LINCOLN SOUTH PLAN CHANGE

Inovo RFI Responses (Final 15.02.2021)

To: Selwyn District Council From: Daniel McMullan, Andrew Tisch
Cc: Bruce Van Duyn, Peter McAuley, Tim McLeod Date: 17 February 2021
Subject: **Lincoln South Plan Change – RFI response to query #8**

Following a plan change request submission to Selwyn District Council (SDC) for 1491 Springs Road south of Lincoln, a number of requests for further information (RFI) have come back from SDC. This memo is in response to RFI #8.

Figure A2: Peak 'velocity x water depth' in a 0.2% AEP flood event including the effects of climate change (2081-2100, RCP8.5)
Model results provided by Selwyn District Council.

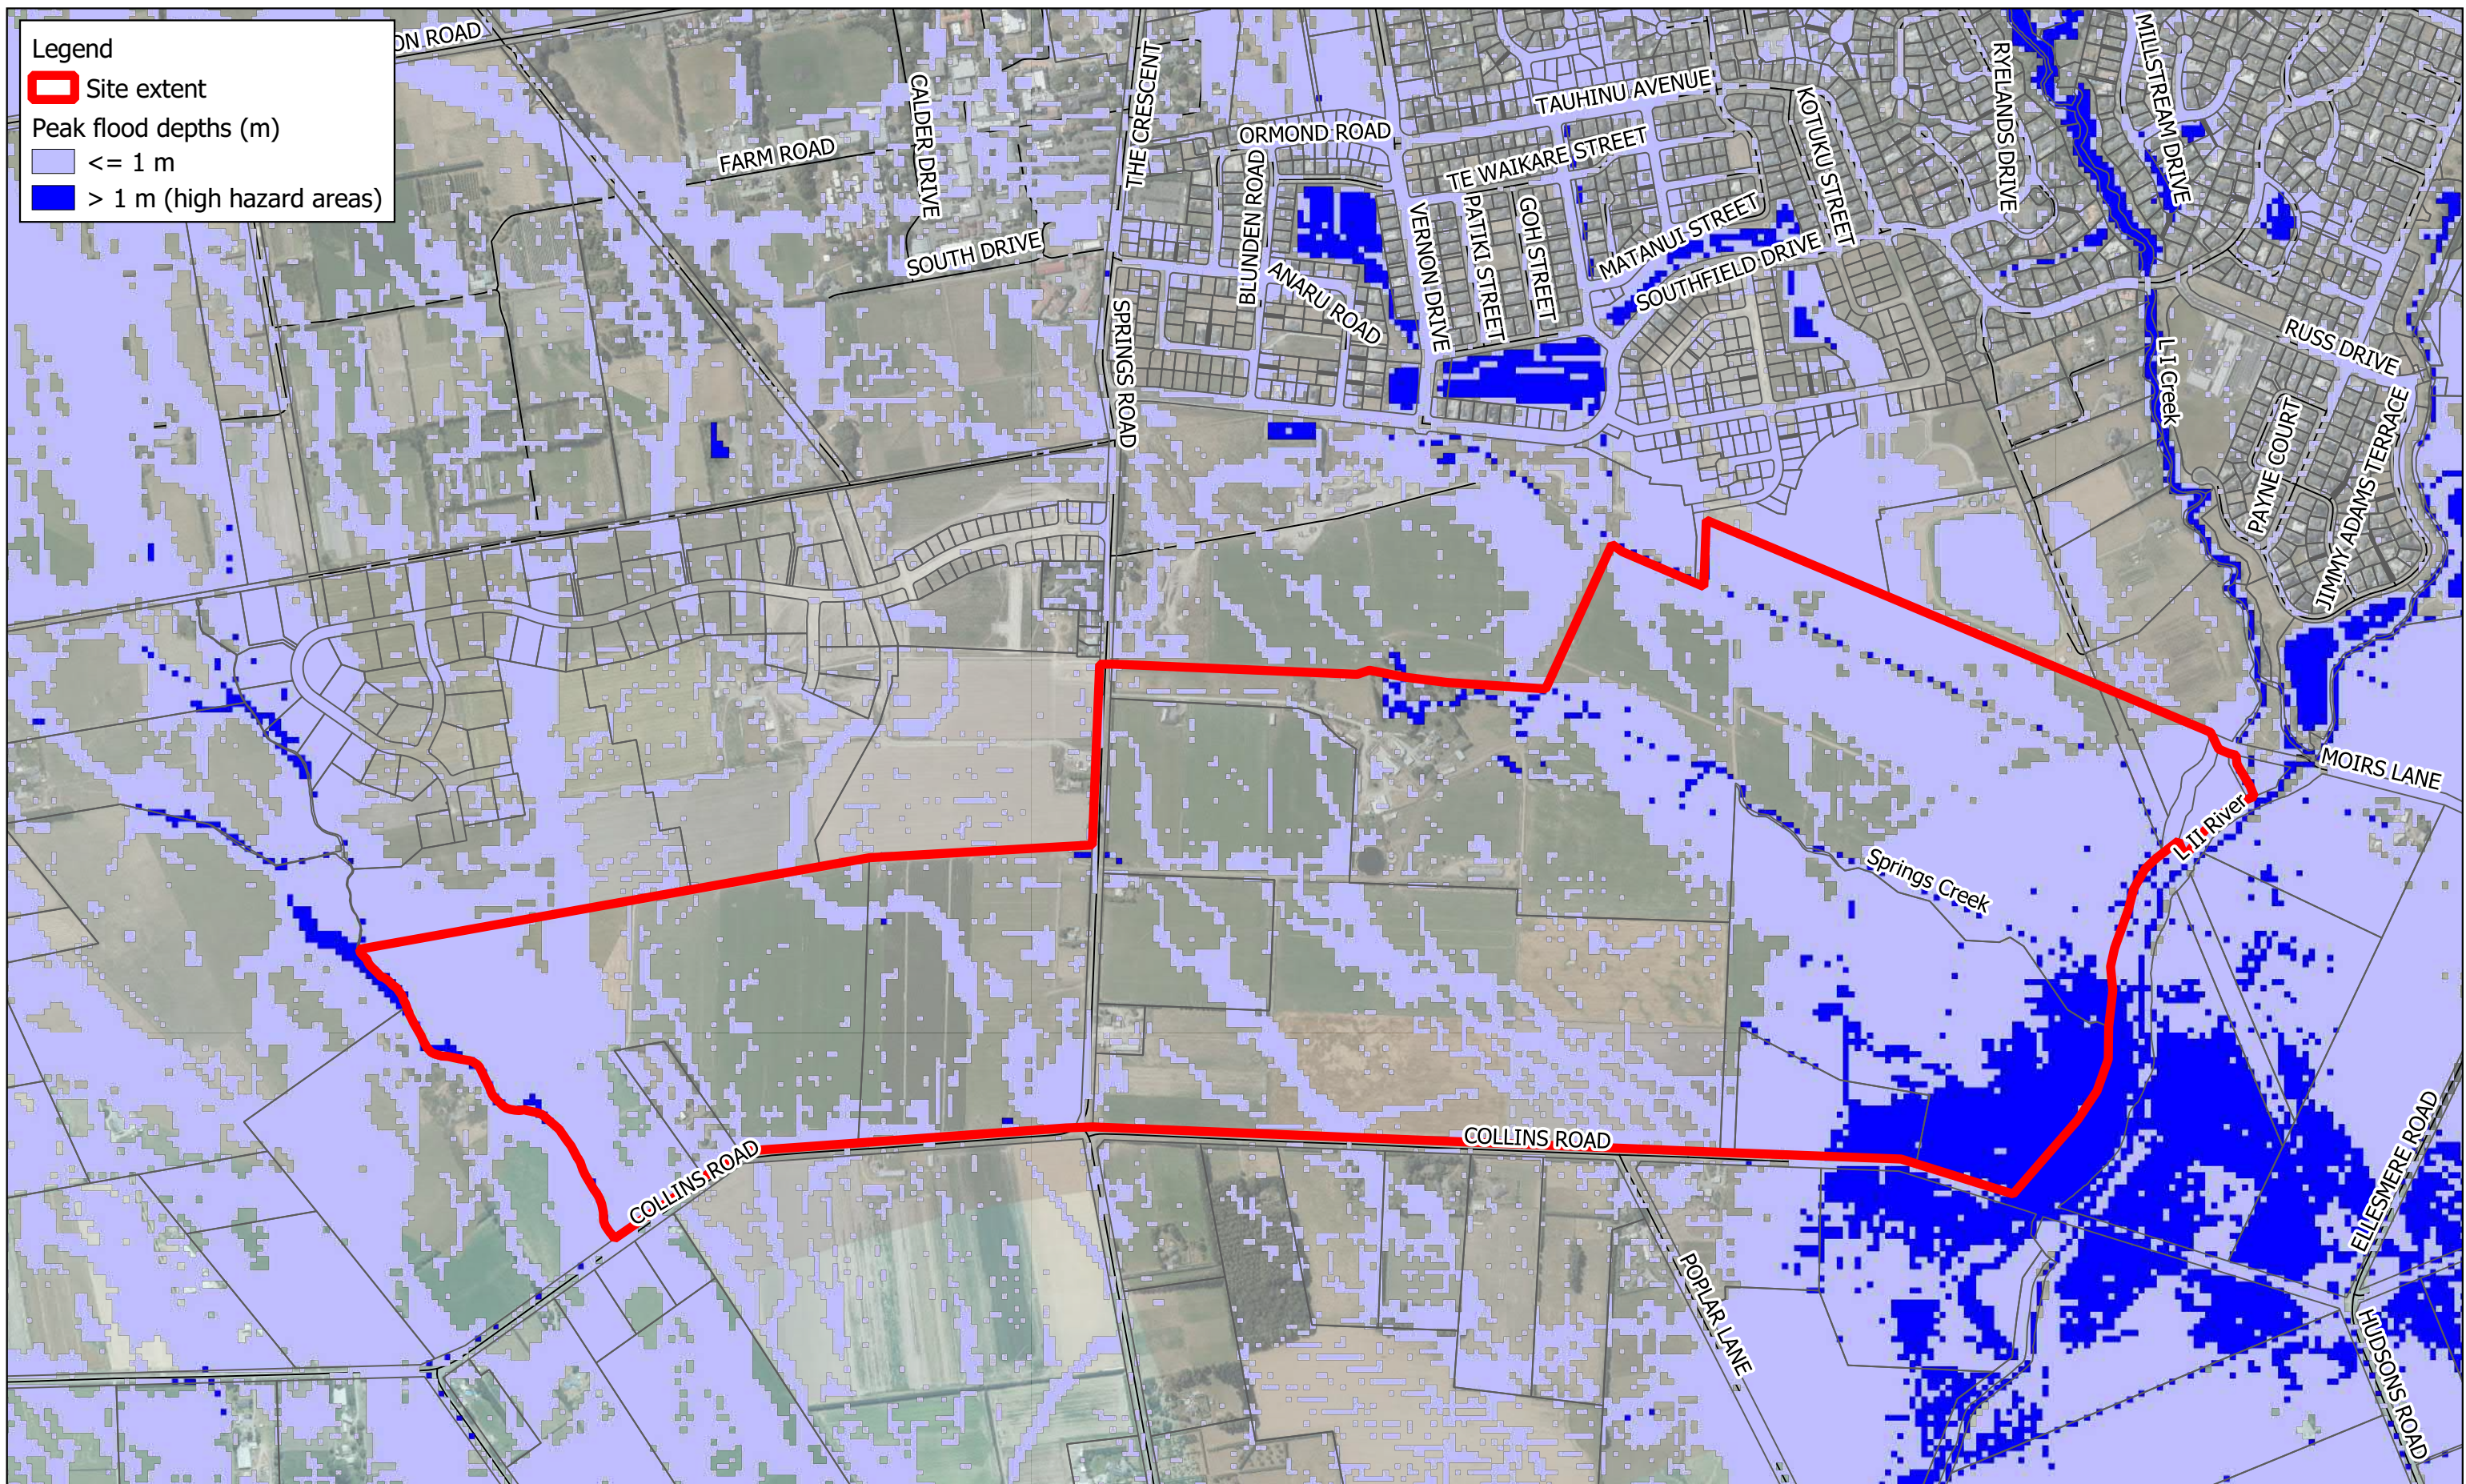
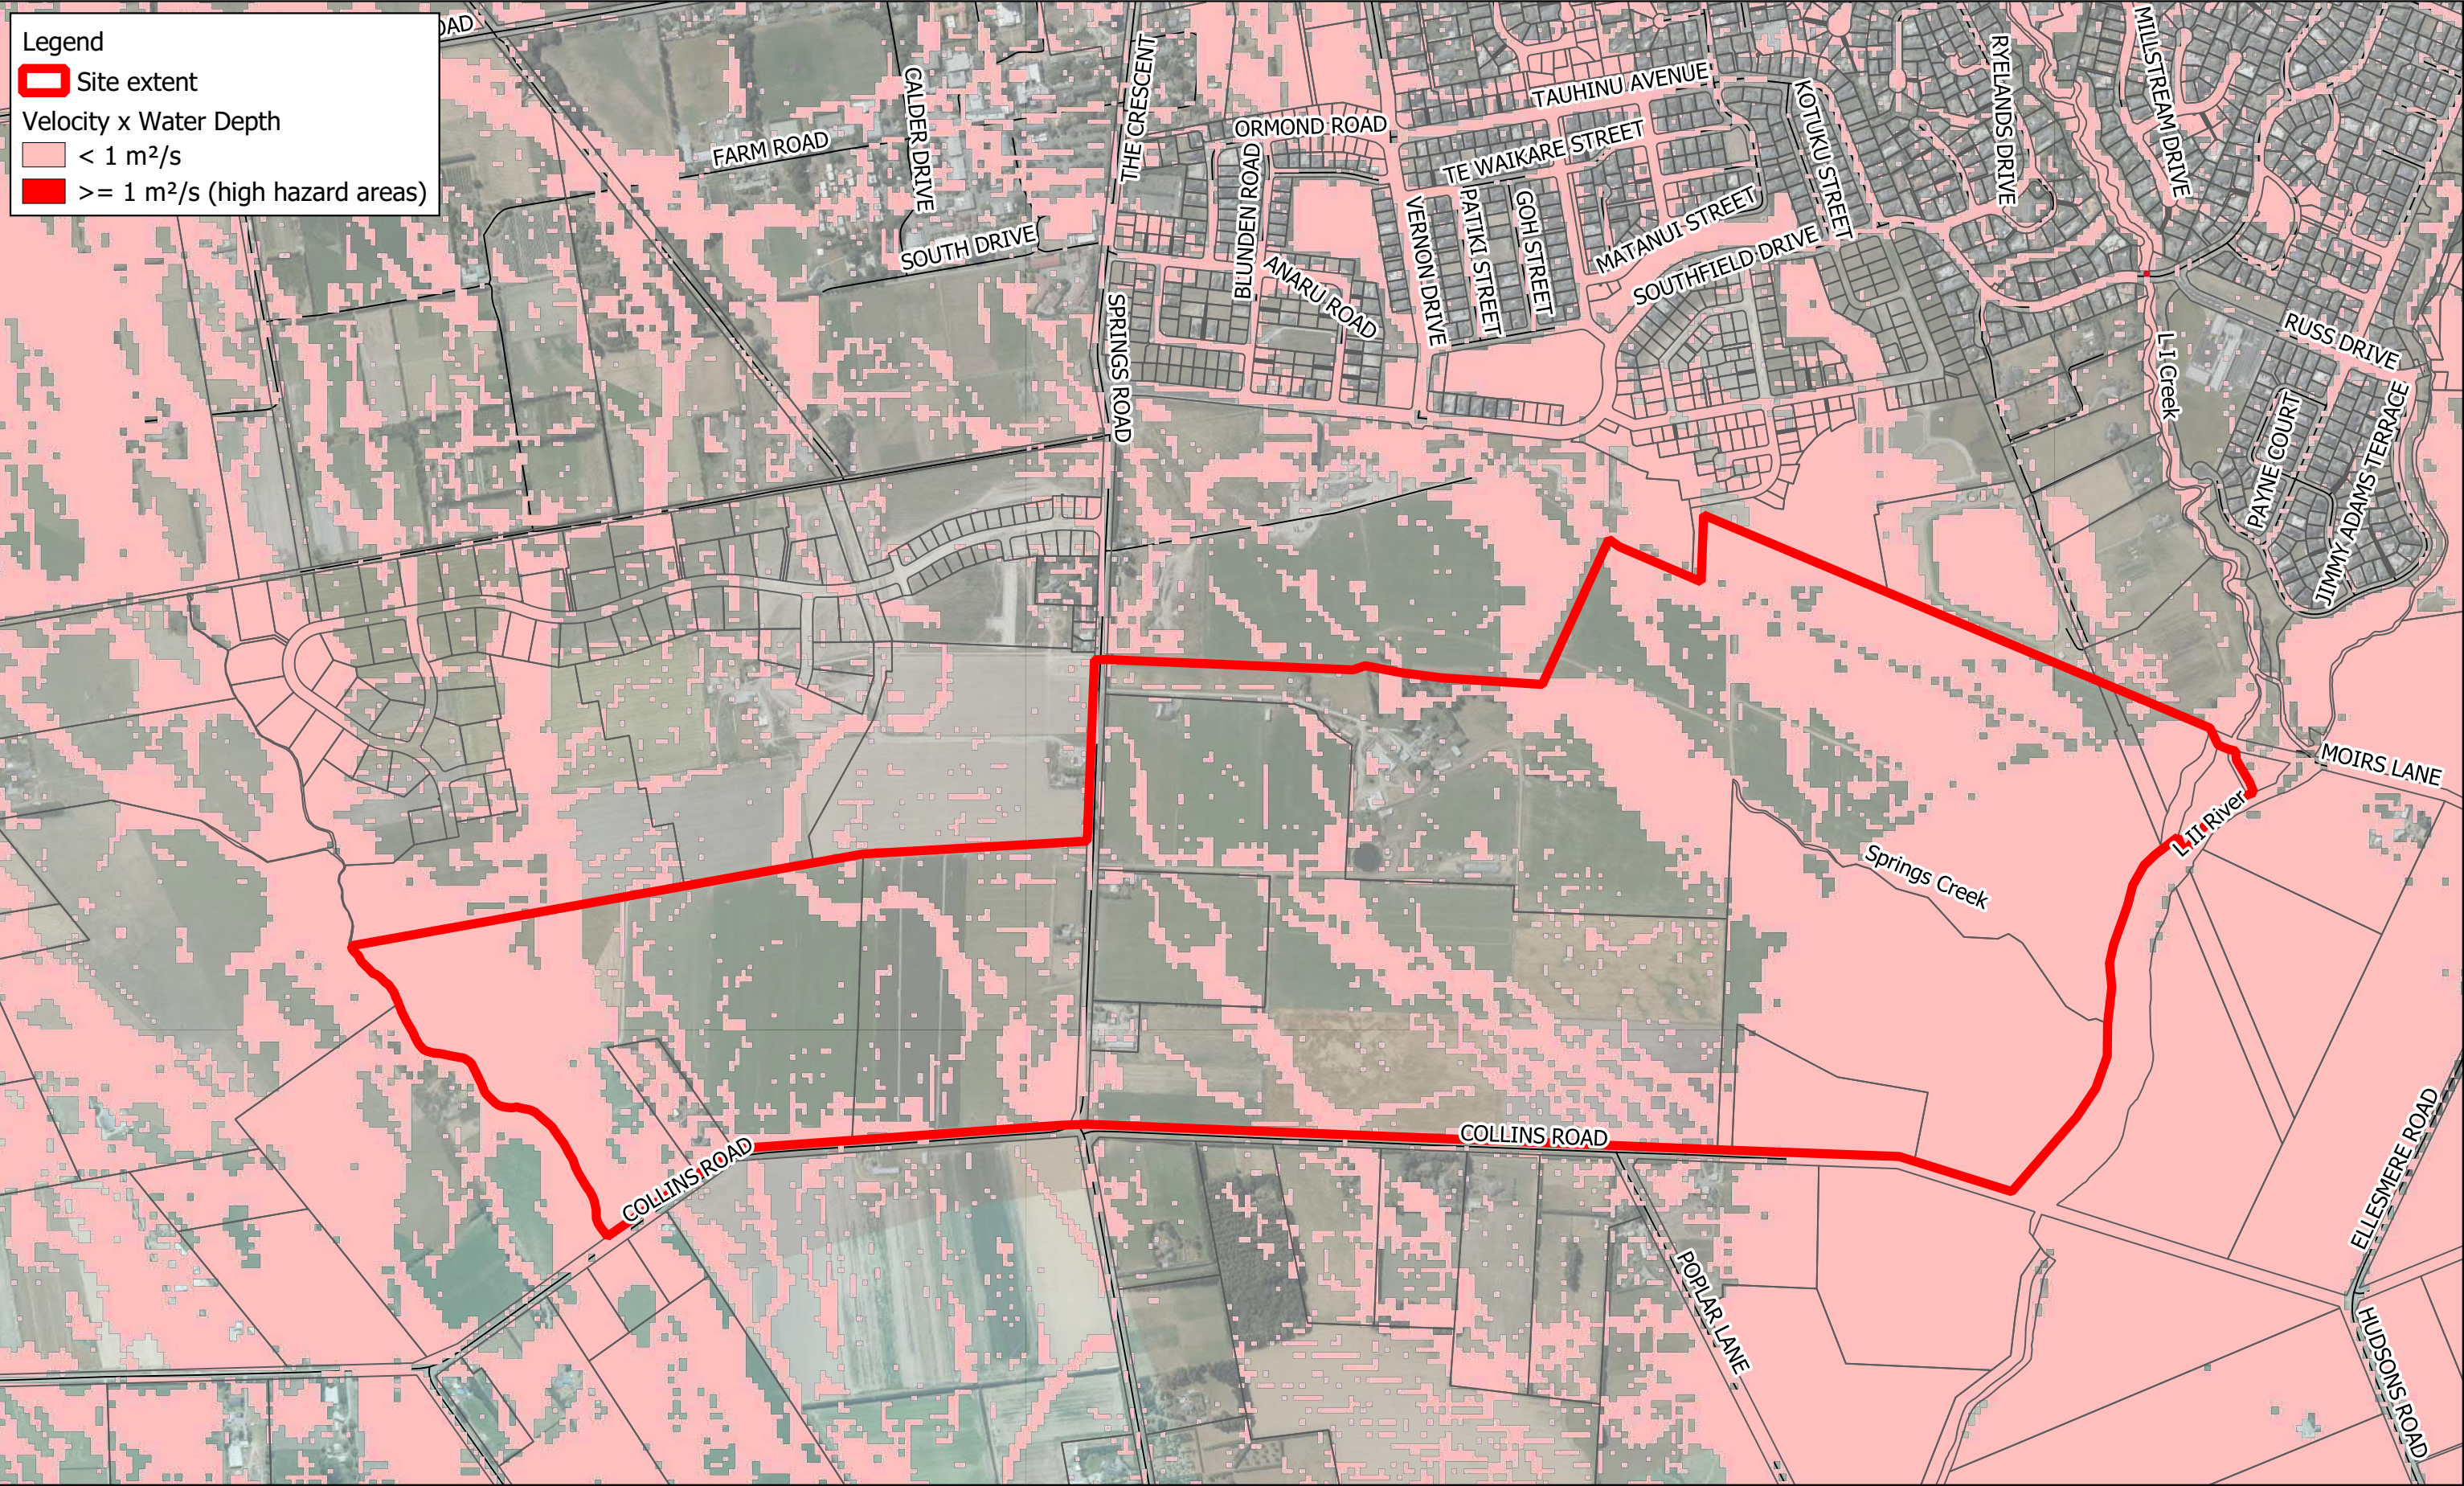
“As acknowledged in the plan change request, the area is subject to inundation in a 200-year Average Recurrence Interval flood event, and that it may contain areas that fall within the Regional Policy Statement definition of ‘high hazard’. Please ensure that the assessment requested above considers CRPS Policy 11.3.2 *Avoid development in an area subject to inundation.*”

Areas of high hazard have been determined based on hydraulic modelling results provided by SDC (H. Roulston, personal communication, November 18, 2020). Plans showing areas of high hazard via peak water depth and peak 'velocity x depth' maps for the 0.2% AEP flood event including the effects of climate change are provided in Appendix A. These show that there are no areas where the velocity x water depth factor is greater than $1 \text{ m}^2/\text{s}$, with areas of water depth greater than 1 m focussed in the ponding area at the south-east corner of the site, along with other areas in waterways and minor depressions. This low velocity x water depth factor will be due to flat gradients on the floodplain, wide overland flow paths that do not concentrate flows, and ponded water that is slow moving despite potentially being relatively deep.

As per CRPS 11.3.1, development in high hazard areas will be avoided. In some minor locations, the high hazard areas identified by the model results will need to be verified against finished levels due to the hydraulic model's coarse representation of the terrain.

CRPS 11.3.2 relates to areas outside of the high hazard area but that are subject to inundation in the 0.5% AEP flood event. In these areas, development will also be avoided where there is increased risk to life. In the subdivision design phase, this would also consider access / egress routes in addition to maintaining appropriate freeboard above the 0.5% AEP flood event for building floor levels. Where suitable, there may be filling of ground levels to above the 0.5% AEP flood level to provide platforms for development. However, this would be dependent upon the ability to provide compensatory storage and ensure there are no negative effects downstream of the site. Existing areas of inundation may also be shifted through the development of stormwater / flood management infrastructure. The effects of climate change will be included in any assessment / design.
